TRAILS AT OVERLAND RANCH - SITE PLAN 1

SITE PLAN

COVER SHEET

SITE PLAN

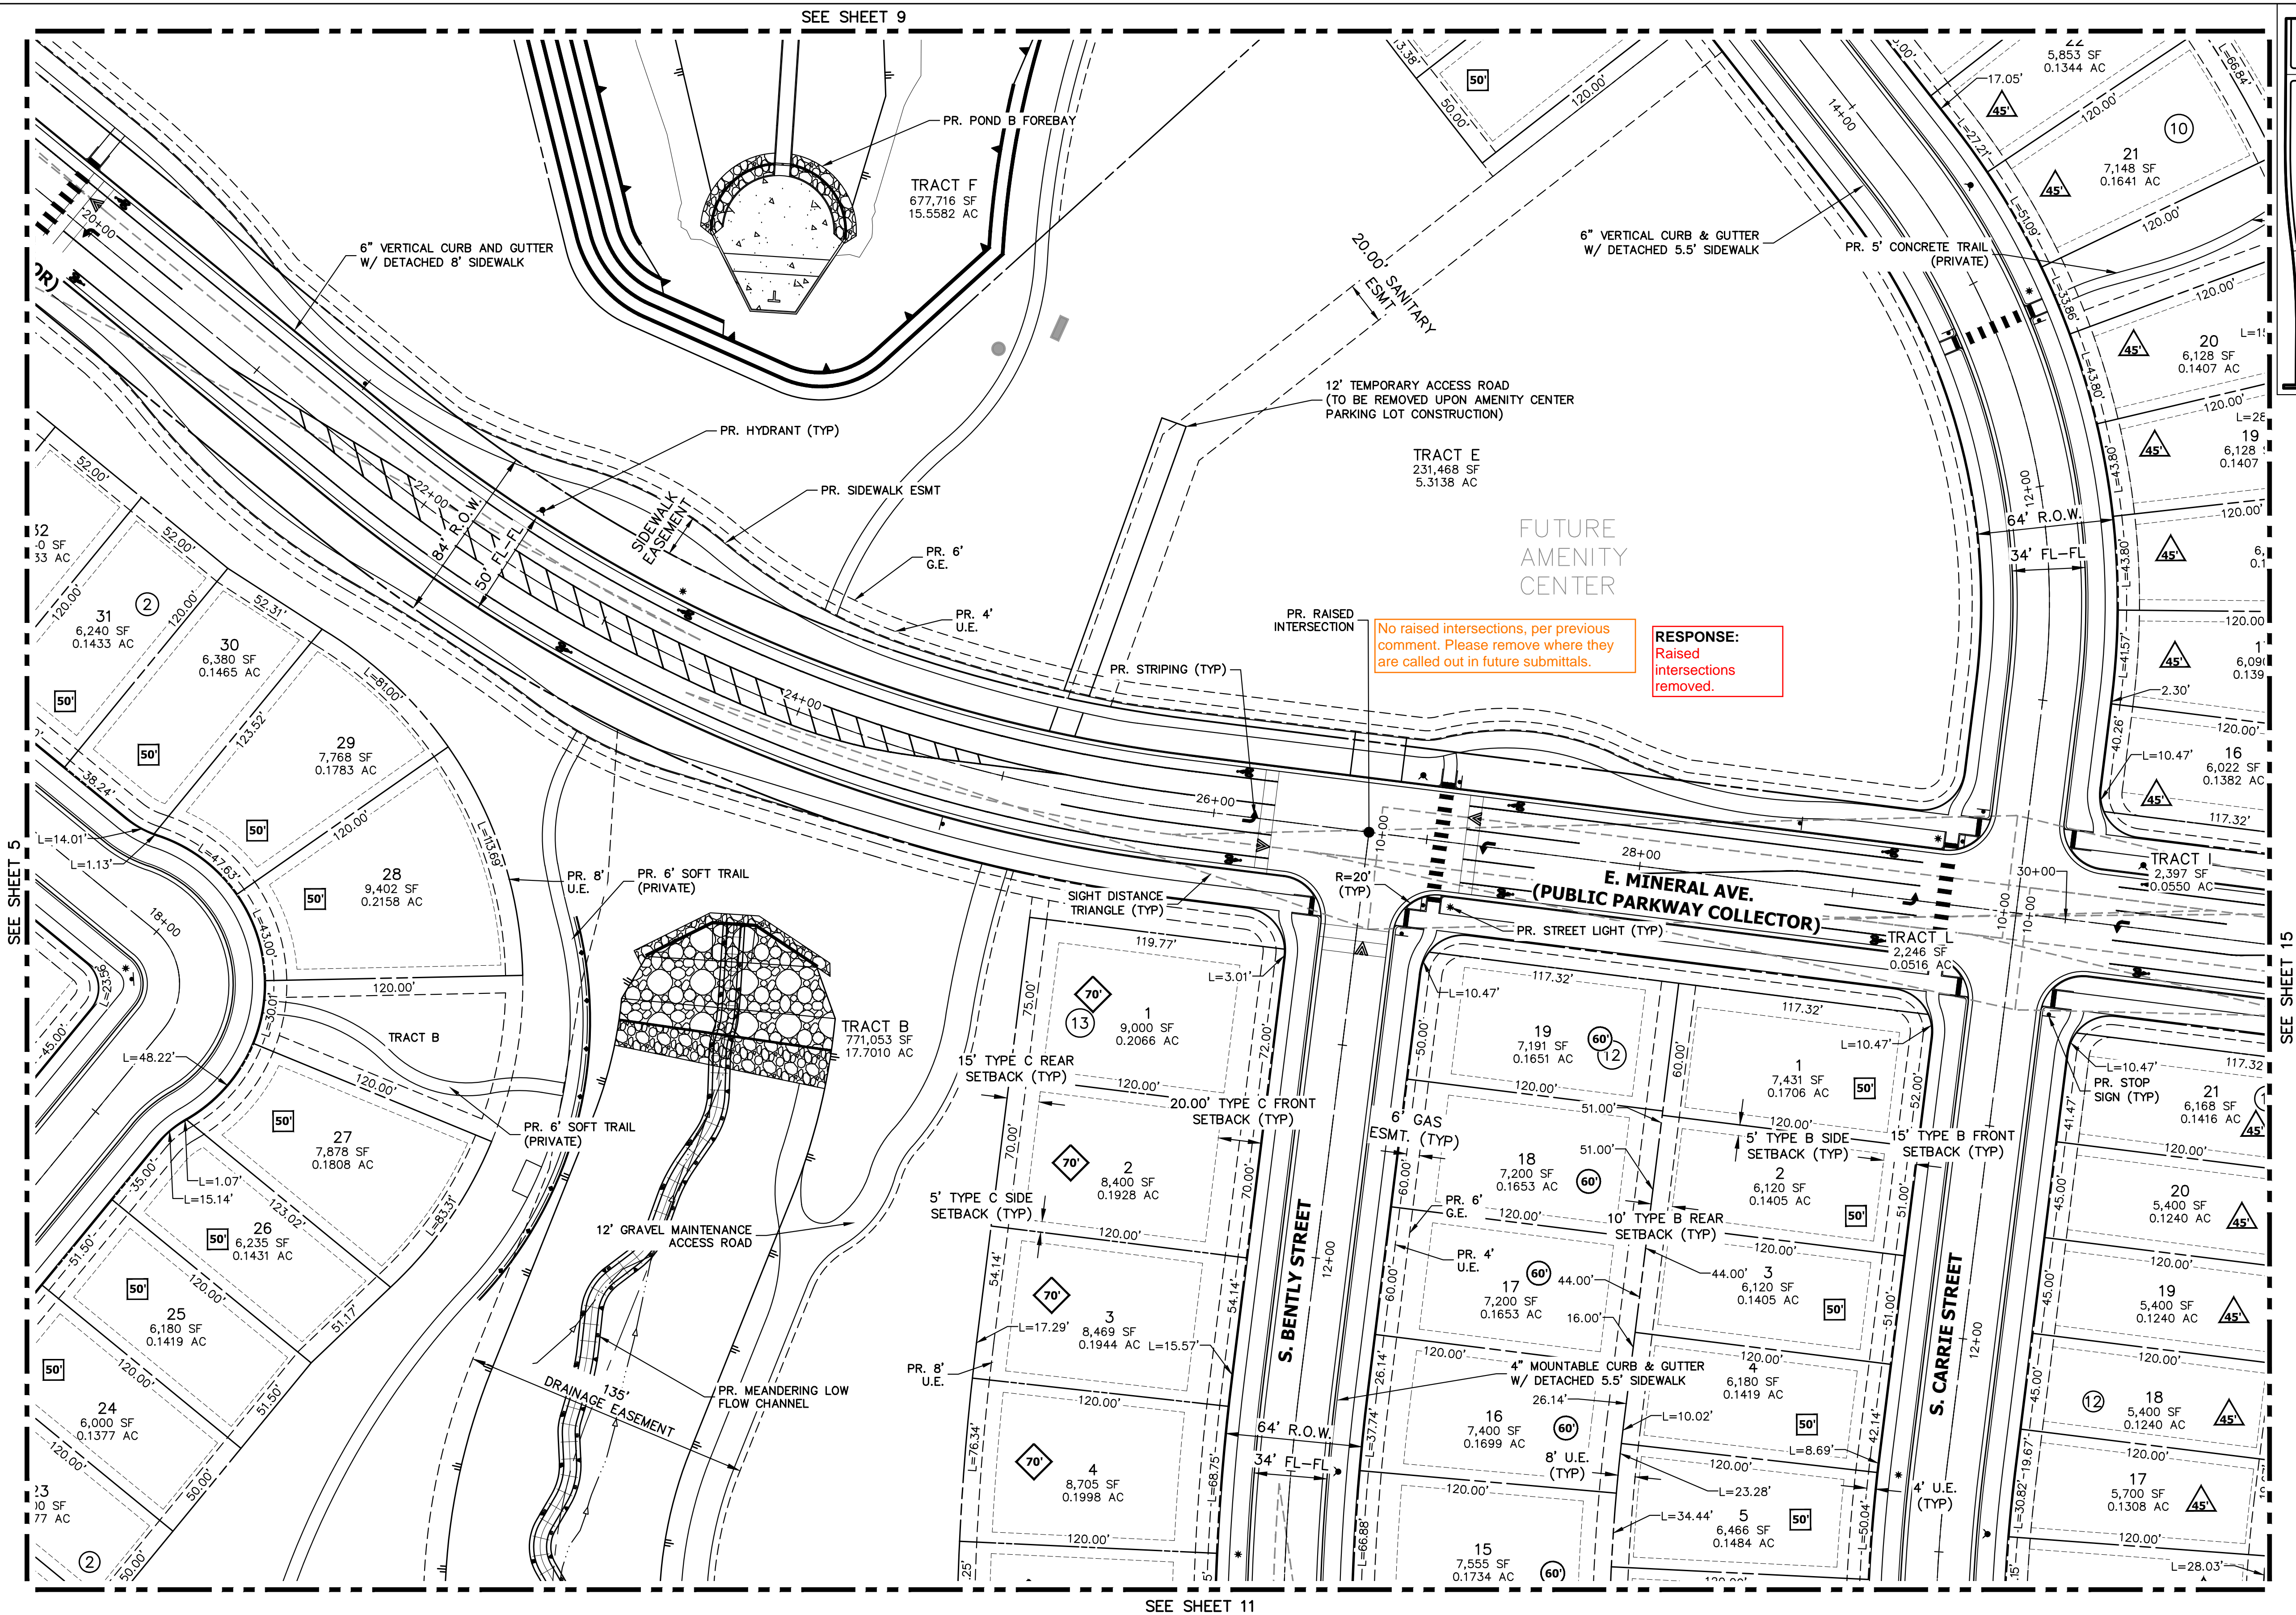
Advisory Comment: Change the R.O.W. lines and Lot lines to be solid continuous (Typ.)

No raised intersections, per previous comment. Please remove where they are called out in future submittals.

RESPONSE:
ROW and lot lines have been revised to be solid continuous.

RESPONSE:
Raised intersections removed.

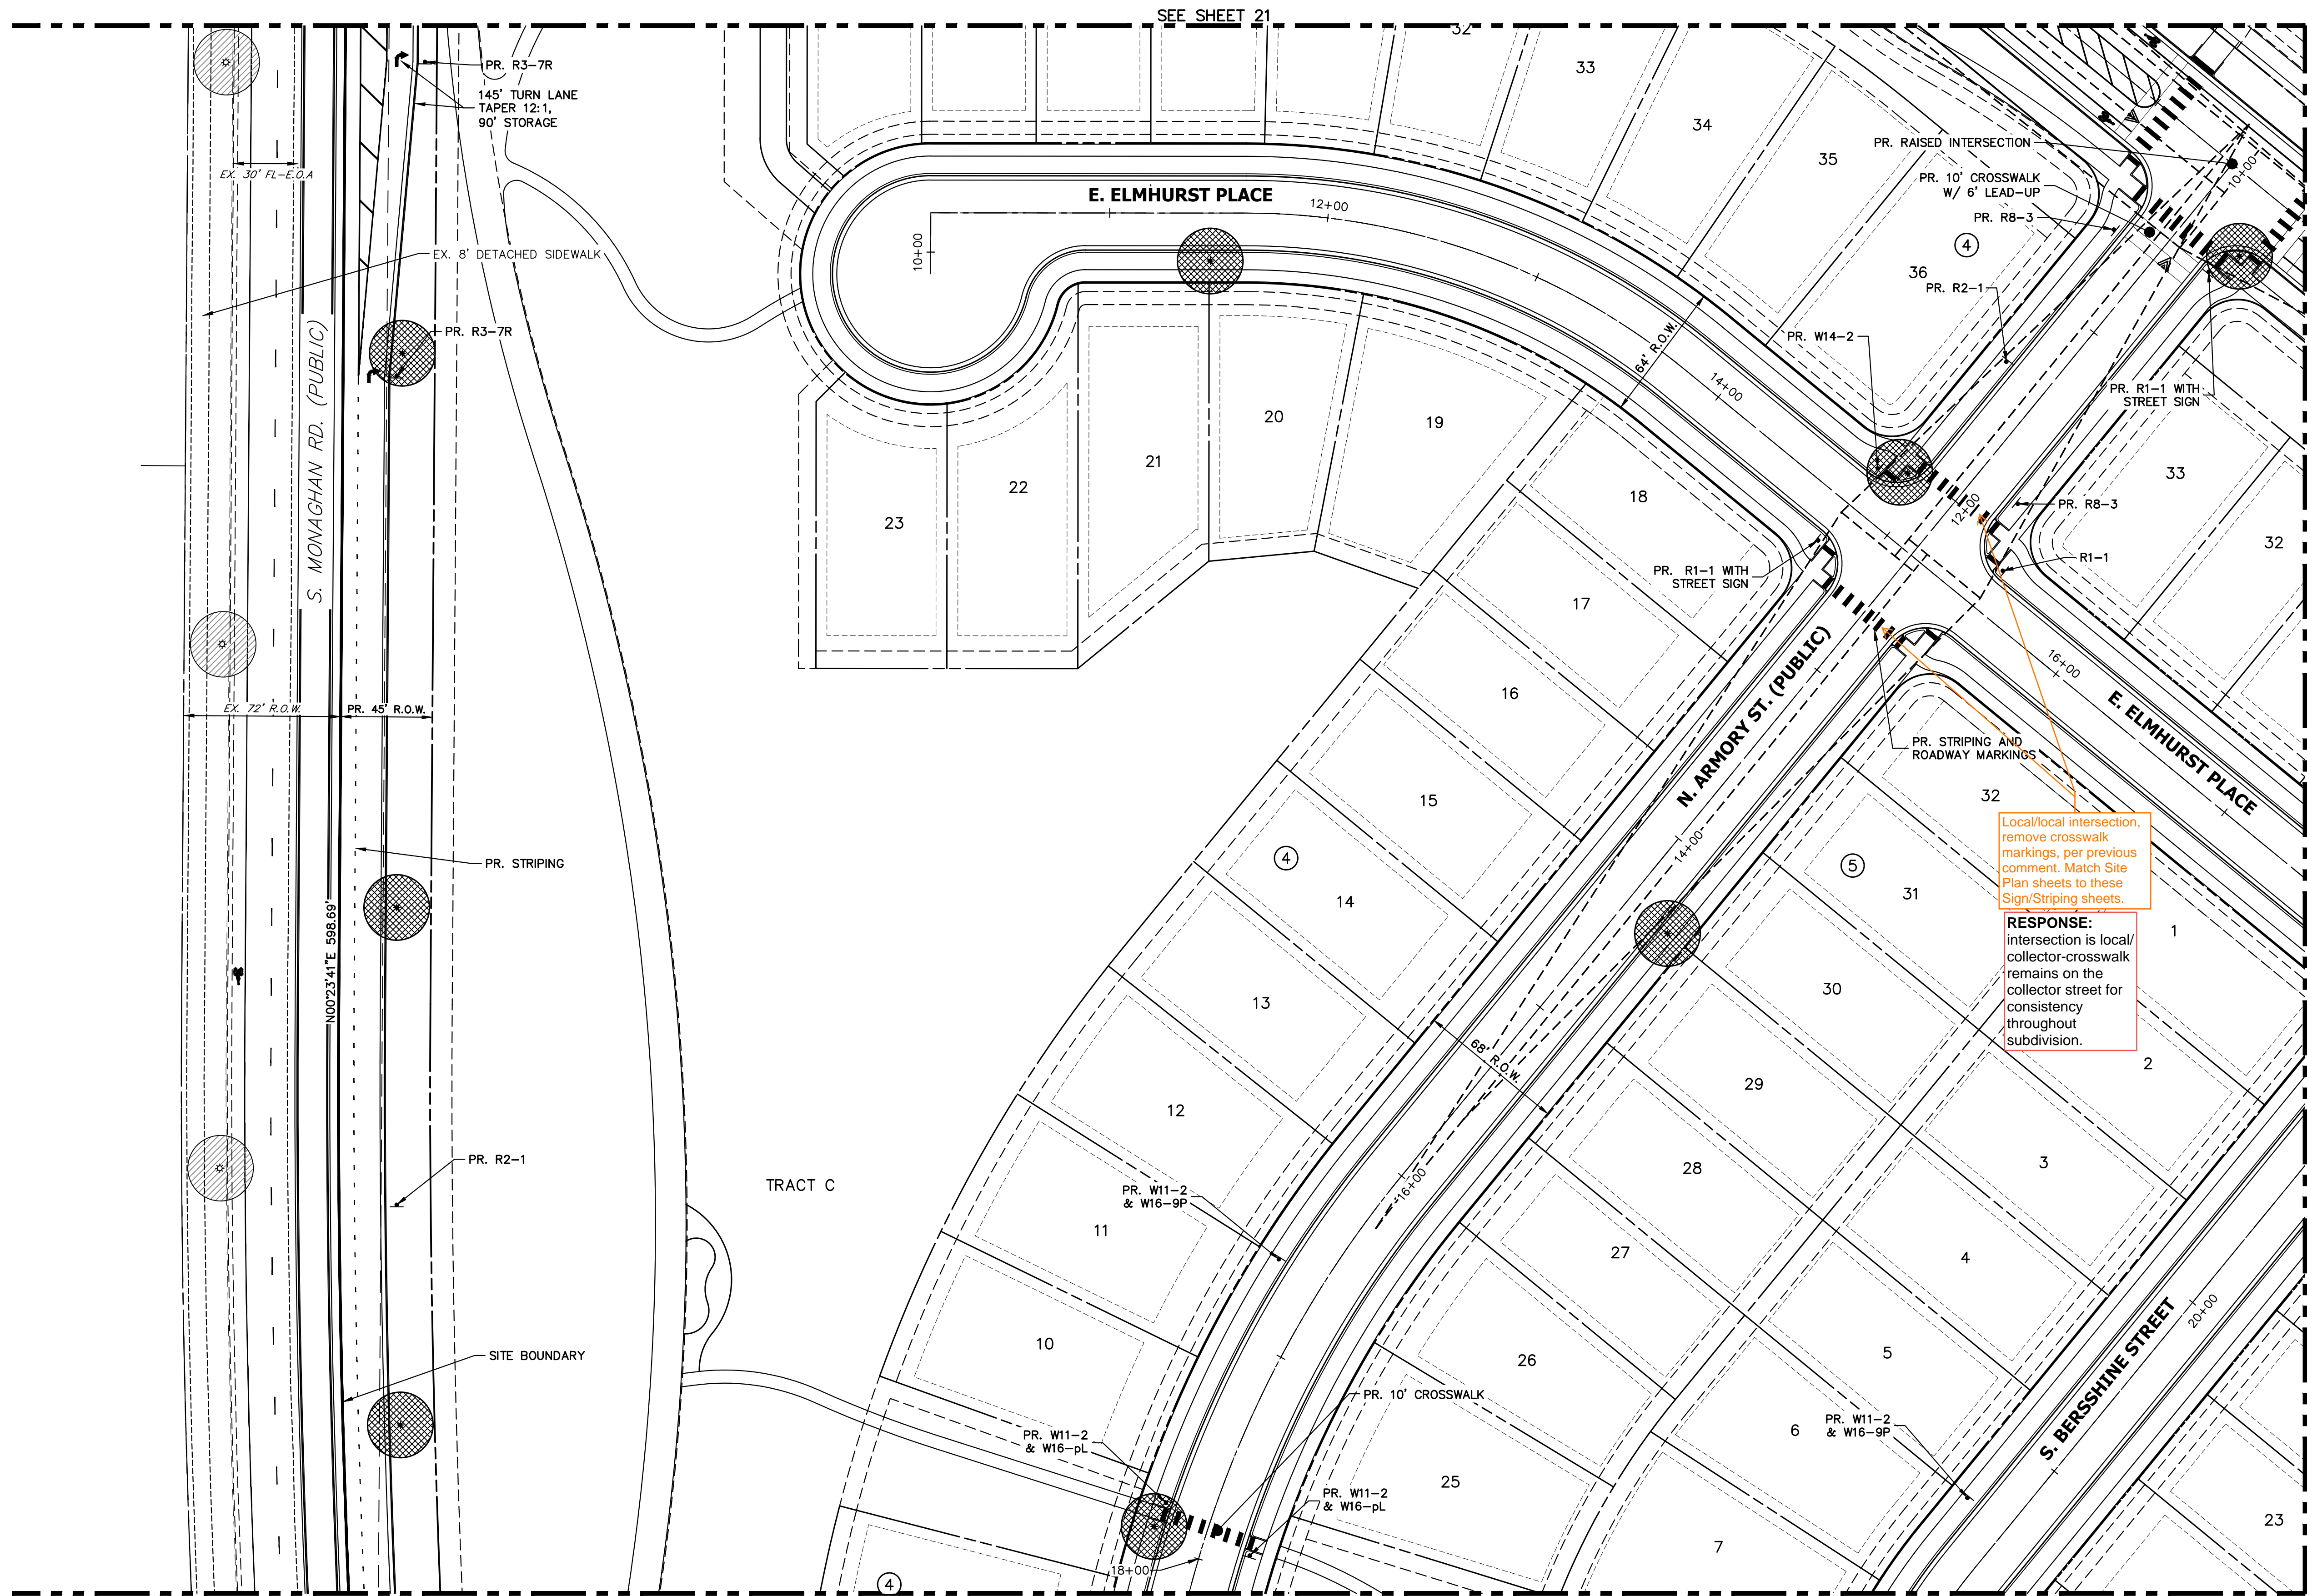
Local/local intersection, remove crosswalk markings, per previous comment. Match Site Plan sheets to these Sign/Striping sheets.

RESPONSE: intersection is local/collector-crosswalk remains on the collector street for consistency throughout subdivision.
